ControlLogix SERCOS Interface Module, Firmware Revision 15

Catalog Numbers 1756-M03SE, 1756-M08SE, 1756-M16SE

Use these release notes for firmware revision 15.37.

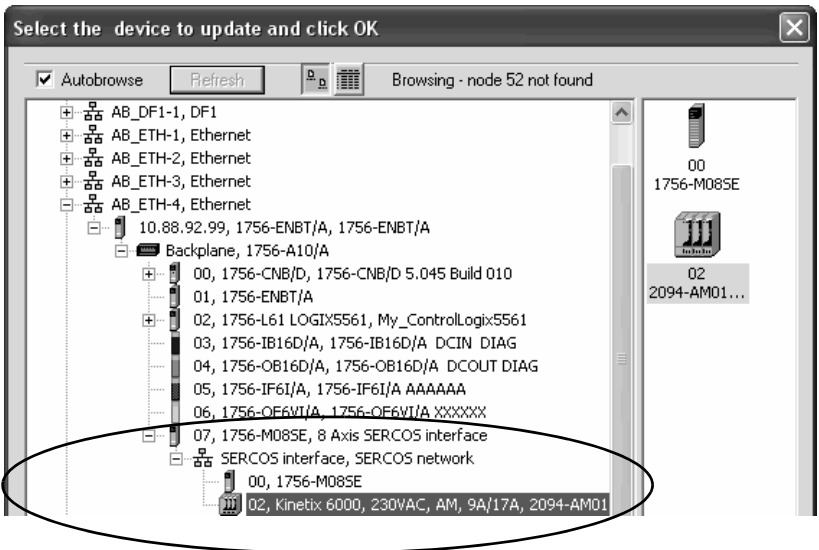
A SERCOS interface module ring drop and service channel issue was identified as a result of an anomaly occurring in the SERCON816 ASIC chip.

Firmware revision 15.37 corrects the SERCON816 ASIC chip anomaly.
